KECK/DEIMOS
DRIVE DISK WALL
0° PANEL

D8796.A

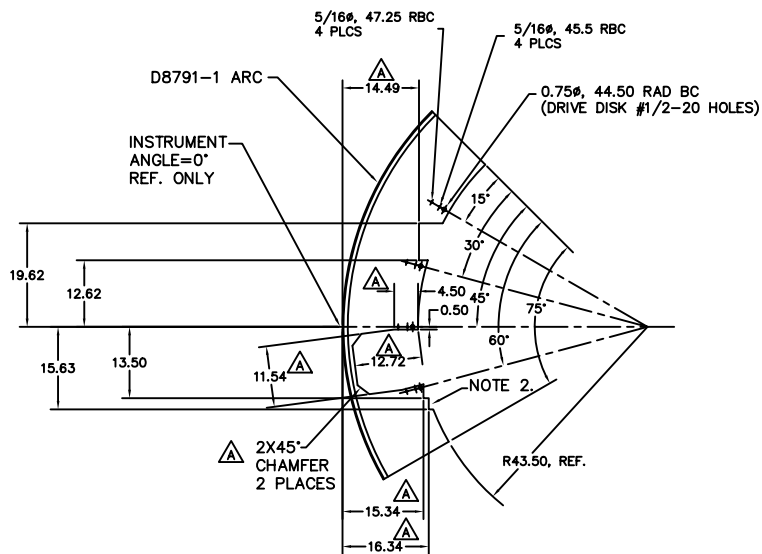
CHANGED BY
ECO # 81601

CHANGE PER ECO 81601: SMALLER O.D. AND
ADD ACCESS SUB-PANEL FOR ROLLER CHECK.
